# **Technical Bulletin/Safety Alert**

### **BULLETIN NUMBER;- TBSA (0501)**

## Subject:- Damage to scrubber protection/ access cover

New design fitted cover over the scrubber float cam mechanism

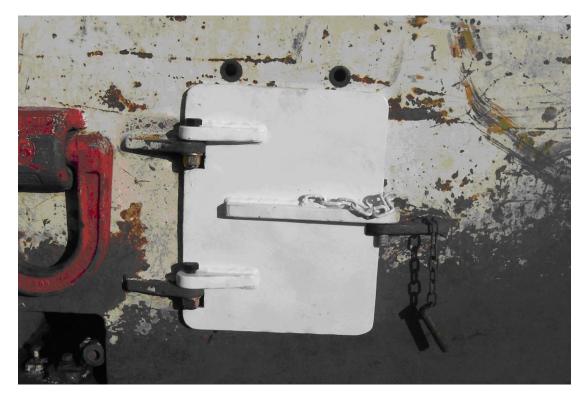
The impact of the vehicle damaged a cover over the float arrangement near the scrubber that in turn damaged the scrubber shut down mechanism. As a result excessive smoke was reported coming from the exhaust. The mine incident report noted a minimal amount of water was found above the test point of the scrubber system. The exhaust particulate filter was also changed at the time as it appeared to be unserviceable.

The cover now encompasses a more sturdy structure and has been designed to sit outside the parameter of the main frame and therefore further away from mechanism affected. This design also gives additional structural support. Please see photo below for new design.

Anderson's part number of the cover is :- 5571723300 and we strongly recommend this modification be carried out as soon as possible. The new cover has been designed to be retrofitted with no machine frame modifications. The hinge and latch point positioning may differ if previous repairs have been carried out by others.
